Project	IEEE 802.16 Broadband Wireless Access Working Group http://ieee802.org/16 >
Title	Clarification of AAS IE and Burst Allocations
Date Submitted	2005-01-13
Source(s)	Inseok Hwang, Jaehee Cho, SeungjooMaeng, Jaeho Jeon, Soonyoung YoonSamsung Electronics Co. Ltd. [is91.hwang@samsung.com]
Re:	Call for comments on working document IEEE 802.16maint-04/10
Abstract	Burst allocation examples in DL/UL AAS zone are illustrated for clarification.
Purpose	Adoption
Notice	This document has been prepared to assist IEEE 802.16. It is offered as a basis for discussion and is not binding on the contributing individual(s) or organization(s). The material in this document is subject to change in form and content after further study. The contributor(s) reserve(s) the right to add, amend or withdraw material contained herein.
Release	The contributor grants a free, irrevocable license to the IEEE to incorporate material contained in this contribution, and any modifications thereof, in the creation of an IEEE Standards publication; to copyright in the IEEE's name any IEEE Standards publication even though it may include portions of this contribution; and at the IEEE's sole discretion to permit othe

Fig. XXX. Burst Allocations in DL AAS Zone

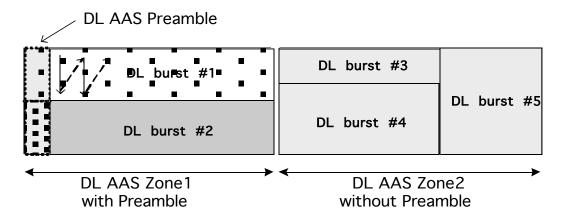
The current text of **IEEE 802.16maint 04/10** does not show that burst allocation examples in AAS zone. When AAS preamble is included in AAS zone, it is natural to count slots right after AAS preamble in the specific AAS zone. This contribution illustrates the figures for correct and incorrect burst allocations.

[Add the following figure after AAS DL IE in Sec. 8.4.5.3.3]

Fig. YYY. Correct and Incorrect Burst Allocations in UL AAS Zone

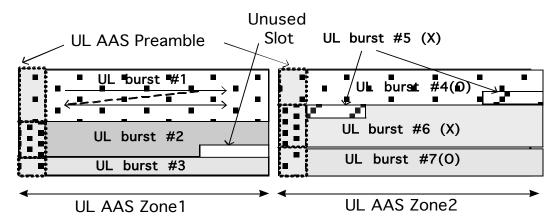
[Add the following text and figure after AAS UL IE in Sec. 8.4.5.4.6]

When AAS preamble is used, slot index in UL AAS zone should start right after AAS preamble and wrap around the AAS zone boundary. Allocation region should not wrap around the AAS zone boundary if AAS preamble used.
